1
2 **DOCUMENT 00 91 13**
3

8 ADDENDUM NO.1 Date: 08.02.21
9

10 RE: SAUK COUNTY COURTHOUSE AND HUMAN SERVICES BUILDING RENOVATIONS
11 515 OAK STREET, BARABOO, WI 53913 and
12 425 6TH STREET, REEDSBURG, WI 53959
13

1 UPPER LEVEL REFLECTED CEILING PLAN
1/8" = 1'-0"

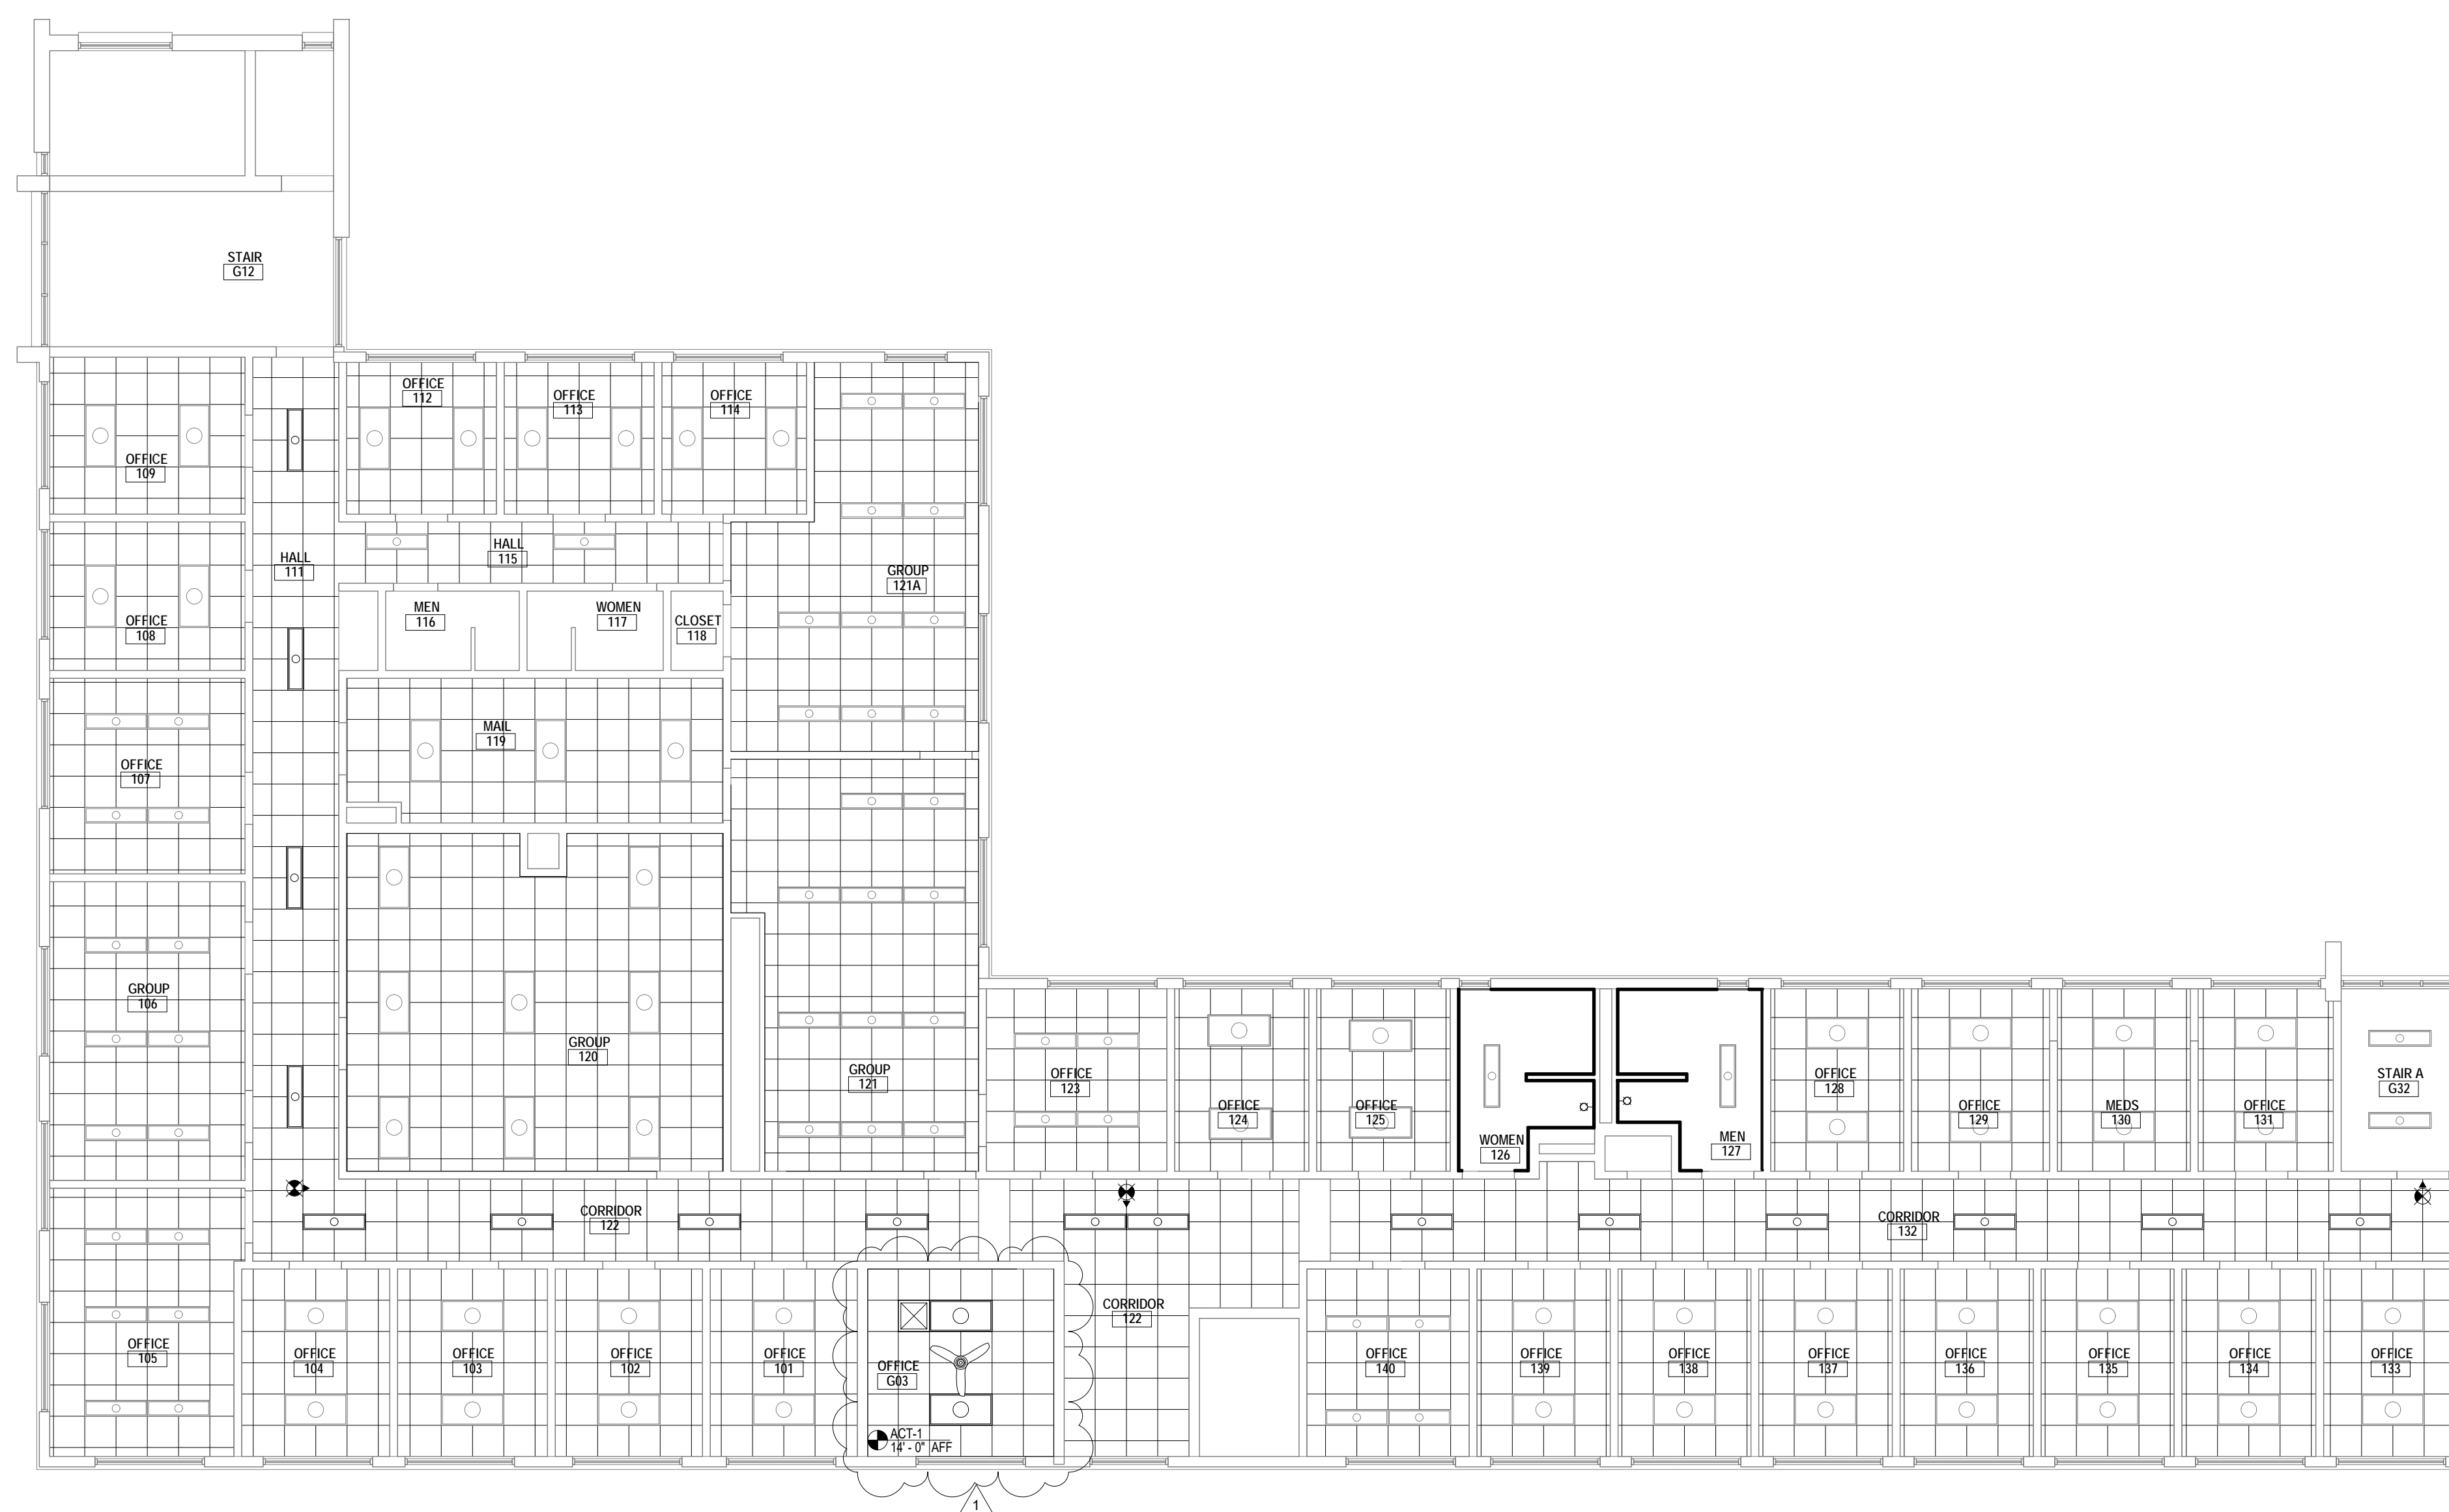
- 24
- 25 16. SHEET A301.2, UPPER LEVEL REFLECTED CEILING PLAN
- 26 a. Replace sheet A301.2 in its entirety with attached A301.2.
- 27 b. Revised Office G03 to reflect existing conditions.

1 LOWER LEVEL FINISH PLAN
1/8" = 1'-0"

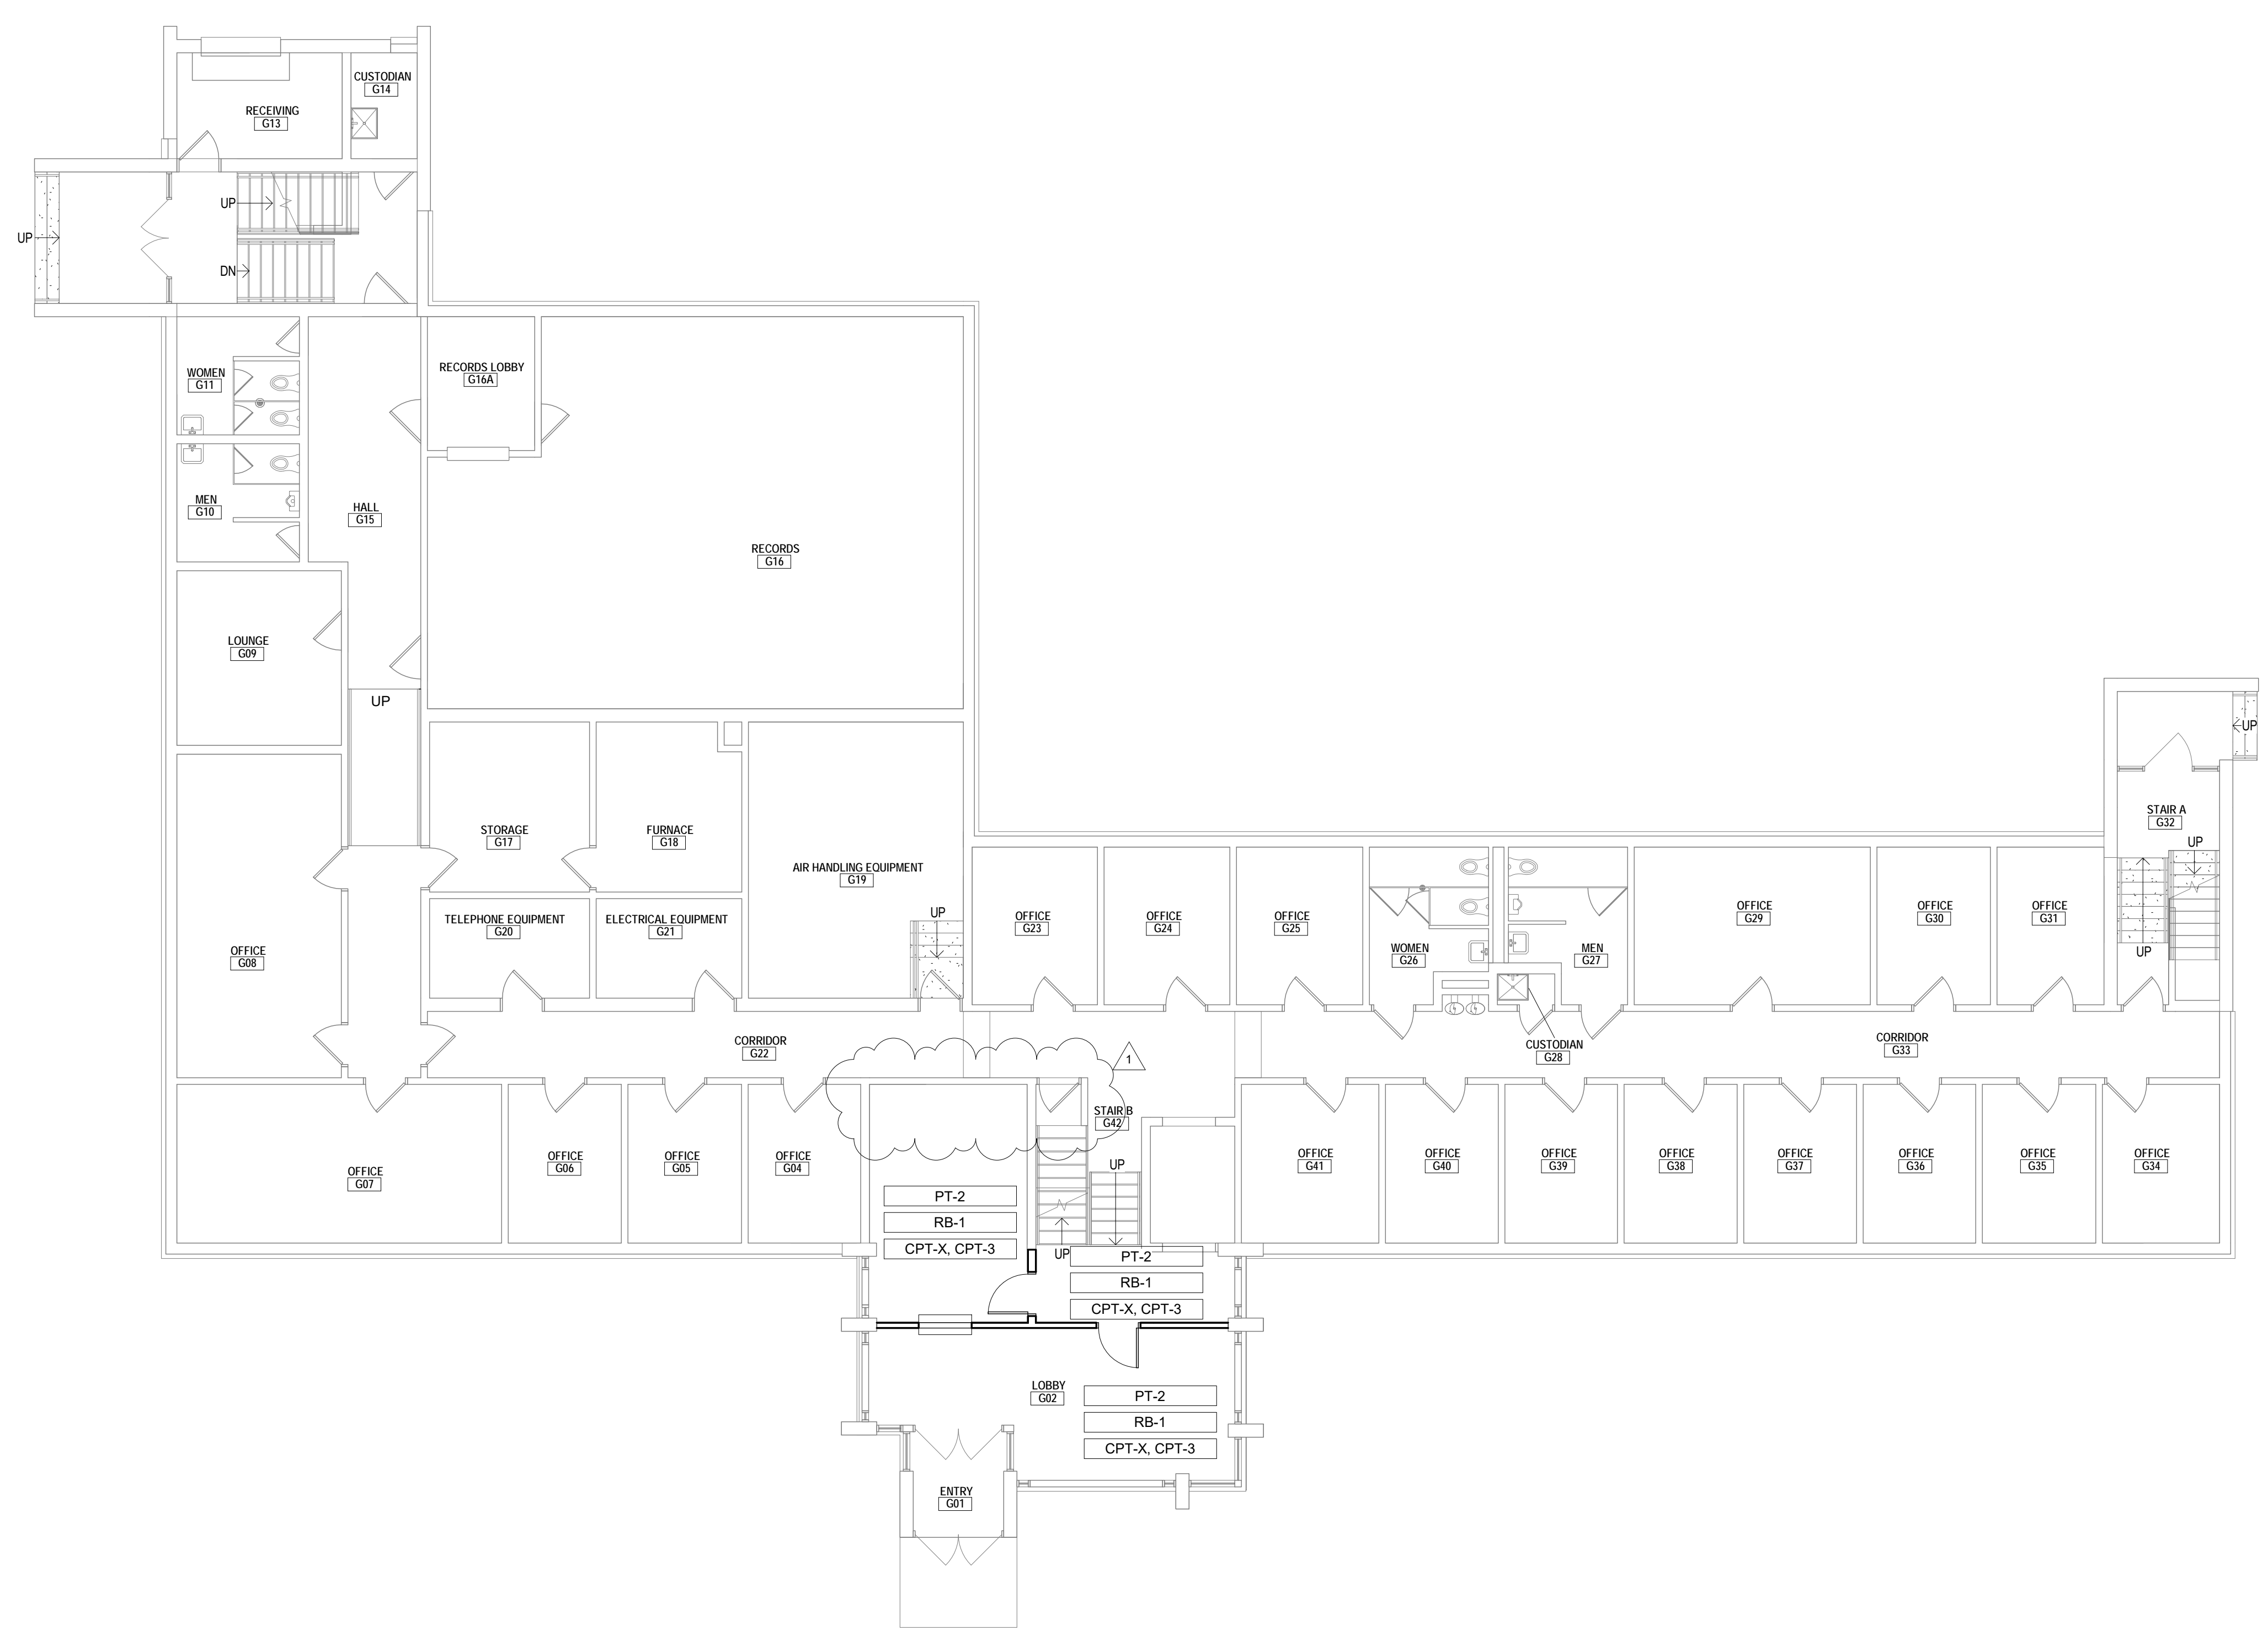
- 32
- 33 18. SHEET A900.2, LOWER LEVEL FINISH PLAN
- 34 a. Replace sheet E102.1 in its entirety with attached E102.1.
- 35 b. Revised Office G03 to reflect existing conditions.
